**CITY OF VAUGHAN**

**EXTRACT FROM COUNCIL MEETING MINUTES OF DECEMBER 10, 2013**

**SIGN VARIANCE APPLICATION**  
**FILE NO: SV.13-017**  
**OWNER: YORK MAJOR HOLDINGS INC.**  
**LOCATION: 1900 MAJOR MACKENZIE DRIVE**  
**BLOCK 5, 65M4061**  
**WARD 1**

**FILE NO: SV.13-017**

YORK MAJOR VILLAGE  
WALMART PYLON SIGN LOCATION PLAN

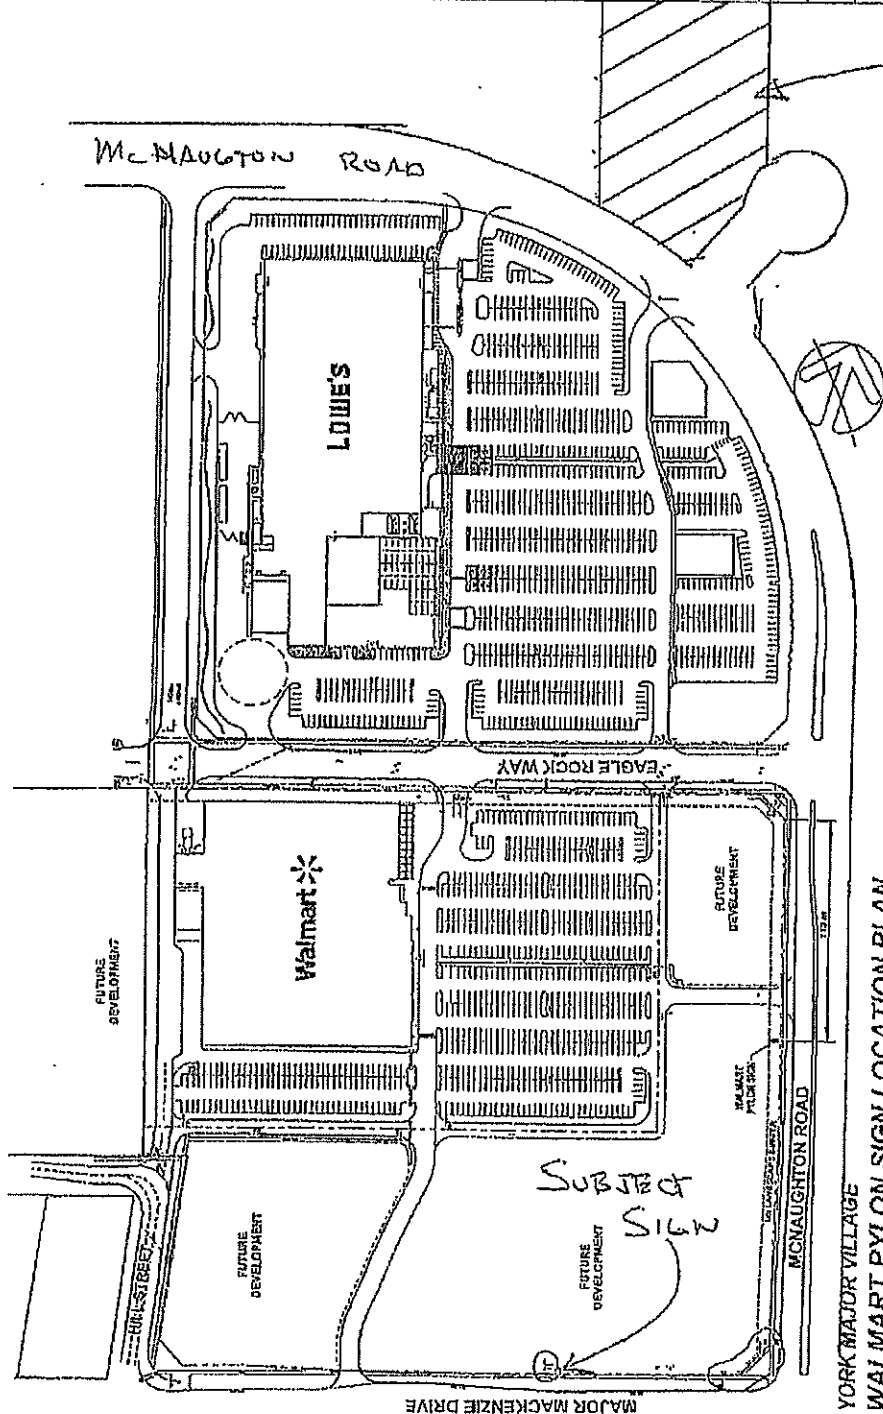
The applicant is proposing a 2.5 sqm. addition to an existing 20.0 sqm. ground sign located at 1900 Major Mackenzie Drive. The proposed sign is to be used for a business located at 211 McNaughton Road - Colaricci Daudlin Tauro Funeral Homes, as shown on the attached site plan.

Similar to previous applications, members of the Sign Variance Committee do not support sign variance applications for 3<sup>rd</sup> party signage within the City. In Committee's opinion, all signage for a business premises should be located on the lot where it exists as required by the by-law.

In Committee's opinion, the intent and purpose of the City's Sign By-law is not being maintained and are recommending that the application be refused.

Pylon Elevation  
Scale: 1/4"=1'-0"

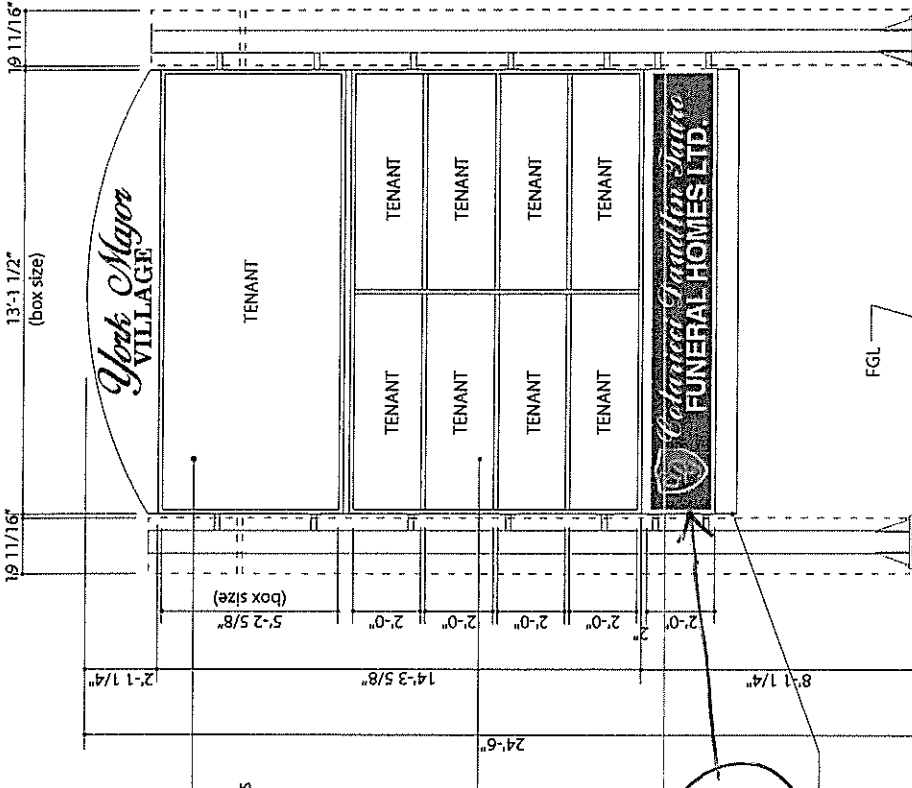
The applicant is proposing a 2.5 sqm. addition to an existing 20.0 sqm. ground sign located at 1900 Major Mackenzie Drive. The proposed sign is to be used for a business located at 211 McNaughton Road - Colaricci Daudlin Tauro Funeral Homes, as shown on the attached site plan.

Similar to previous applications, members of the Sign Variance Committee do not support sign variance applications for 3<sup>rd</sup> party signage within the City. In Committee's opinion, all signage for a business premises should be located on the lot where it exists as required by the by-law.

In Committee's opinion, the intent and purpose of the City's Sign By-law is not being maintained and are recommending that the application be refused.
